TO: T10 Membership
FROM: Paul A. Suhler, Quantum Corporation
DATE: 30 April 2008
SUBJECT: T10/07-469r3, ADT-2: Internet ADT (iADT)

Changes to ADT-2 rev. 5

Figure 12 – Example of shared iADT socket in an automation device

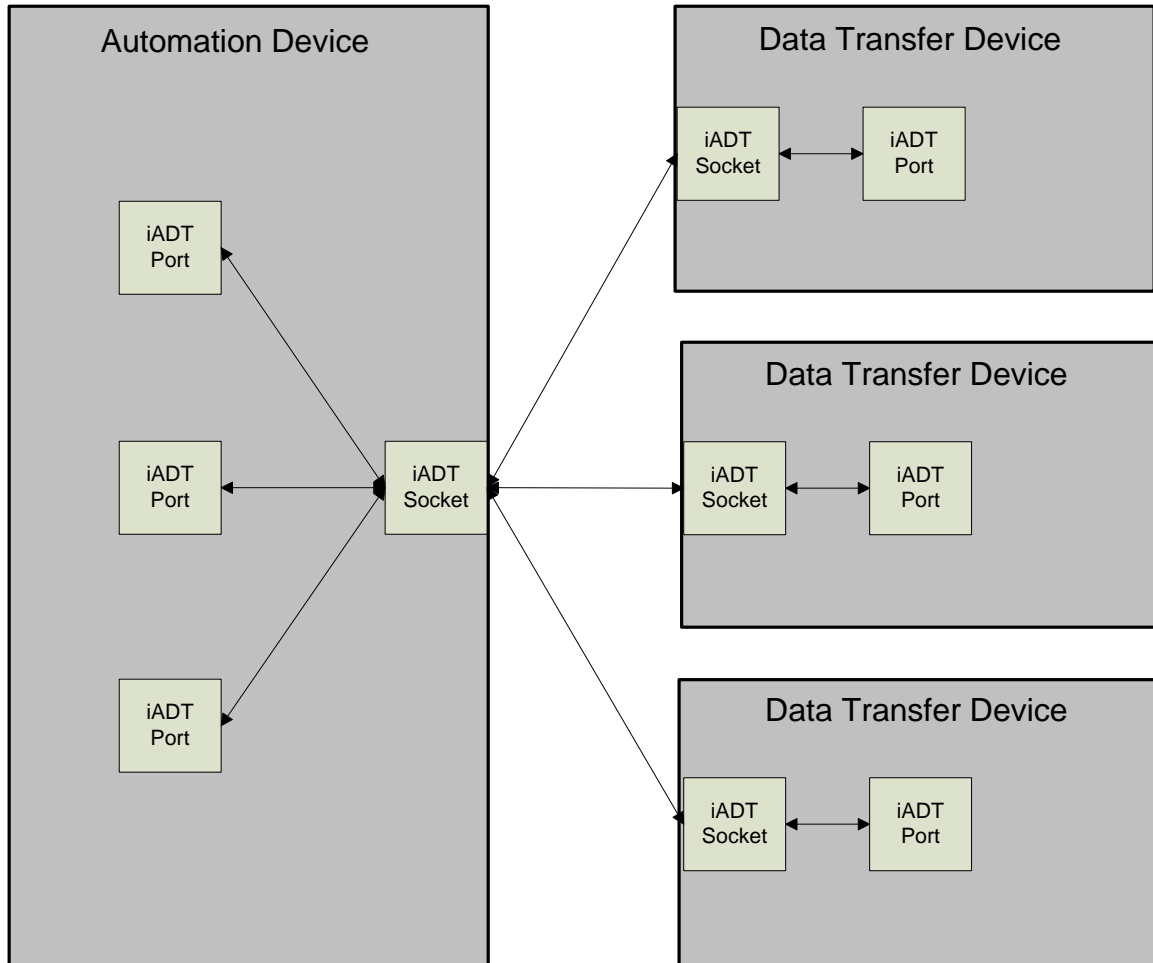
One physical network port may respond to multiple internet addresses, and thus may contain multiple iADT sockets, one for each of the internet addresses. If a device (e.g., device A) contains only one iADT socket (i.e., there is one Ethernet port and it responds to a single internet address) then that iADT socket may be connected to iADT sockets in different devices. Each of those iADT connections connects to a different ADT port in device A. (See Figure 12.)

Editor's Note 1: Should some of this go in the model section?
